SUBDIVISION REVIEW SHEET**CASE NO.:** C8-2020-0188.0A**COMMISSION DATE:** March 22, 2022**SUBDIVISION NAME:** 1940 Webberville Road**ADDRESS:** 1940 Webberville Road**APPLICANT:** Enge Xing (1940 Webberville Road, LLC)**AGENT:** Alberto Gutierrez (Southwest Engineers, Inc.)**ZONING:** SF-3-NP (single family residence)**NEIGHBORHOOD PLAN:** MLK-183**AREA:** 1.008 acres (43,908 sf)**LOTS:** 5**COUNTY:** Travis**DISTRICT:** 1**WATERSHED:** Fort Branch**JURISDICTION:** Full Purpose**SIDEWALKS:** Sidewalks will be constructed along Webberville Road.**VARIANCE:** N/A**DEPARTMENT COMMENTS:**

CITY OF AUSTIN –DEVELOPMENT SERVICES DEPARTMENT
SUBDIVISION APPLICATION – MASTER COMMENT REPORT

CASE NUMBER: C8-2020-0188.0A
REVISION #: 00 UPDATE: U1
CASE MANAGER: Cesar Zavala PHONE #: 512-974-3404

PROJECT NAME: 1940 Webberville Road Subdivision
LOCATION: 1940 WEBBERVILLE RD

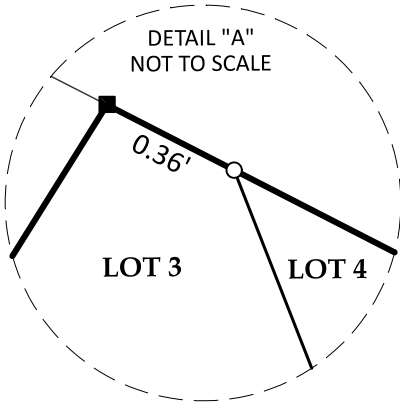
- ATD 1. A joint-use driveway used as alternative access for a single-family residential use may serve not more than eight dwelling units. LDC 25-6-451(C). Provide a plat not restricting the number of dwelling units accessing the single joint use access easement driveway.
U1: Comment Cleared.

- ATD 2. If more than 3 residences are served by a single joint use driveway, the following requirements shall apply:
U1: Plat notes 22, 23, and 24 should be removed from sheet 2. Please remove the additional sentence at the end of note 27.

- ATD 3. Show a survey tie across all existing streets bordering or traversing this subdivision and show the entire right-of-way for Webberville Rd. to verify right-of-way width. LDC 25-4-131.
U1: It appears that the ROW dedicated on the plat may be more than necessary in locations. Total ROW required per ASMP is 78'. From the centerline of Webberville Rd. 39' should be dedicated on applicant side of roadway. GIS data indicates existing ROW is 63' at the most, so confirmation of dedication amount may be needed. Comment will be cleared after

- ATD 4. Please remove "for street purposes" from the label in the hatched dedication area.
U1: Comment Cleared.

SR 6. If fiscal is required replace Note #11 with the following note. 25-1-83, 25-4-38, 25-4-84 or 30-1-113, 30-2-38, 30-2-84

Update 1: Verify if fiscal is needed for the case. If fiscal is not needed, remove note #11.

SR 7. Verify if notes #23, 24 and 25 are applicable to the plat, contact the City of Austin Transportation Department reviewer to determine if the notes are needed on the plat. 25-1-83

Update 1: Comment Pending ATD verifying notes # 22, 23, and 24 on the updated plat.

SR 17. **Update 1:** Remove last sentence from note #27

AW2. Per Utility Criteria Manual Section 2, §25-4, and the Uniform Plumbing Code:
Remove note 15. This is a duplicate of note 16 and not the correct verbiage for the note.
